PRODUCT/PROCESS CHANGE NOTICE (PCN)

PCN #: A0705-01 DATE: 6/11/2007 Product Affected: Ceramic DIP, Sidebraze and Topbraze of 28 leads or more (Refer to Att. II for affected part numbers) Date Effective: 9/11/2007	MEANS OF DISTINGUISHING CHANGED DEVICES: <input type="checkbox"/> Product Mark <input type="checkbox"/> Back Mark <input type="checkbox"/> Date Code <input checked="" type="checkbox"/> Other Shipment starting from 9/11/2007
---	---

ATTACHMENT I - PCN #: A0705-01

Figure 1: Existing material - Silicon bump

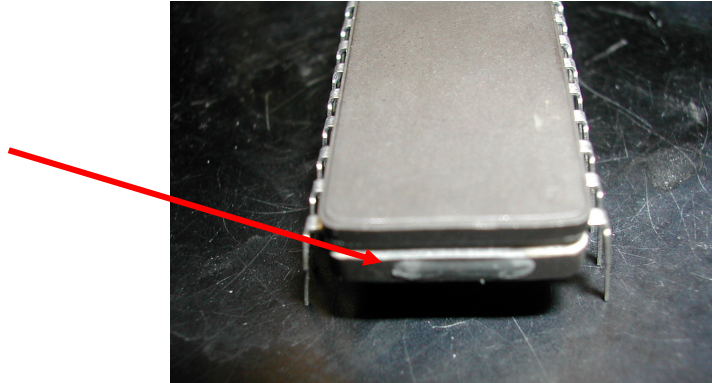
PCN Type: Assembly Material Change
Data Sheet Change: None
Detail Of Change: This notification is to advise our customers that there will be a change of material from silicon bump to bumper tape, which is applied at the package end (opposite pin 1) to prevent package crack or chip as a result of knocking between units.

Description	Existing Material	New Material
Material	Silicon bump	Bumper tape

Figure 2: New material - Bumper tape
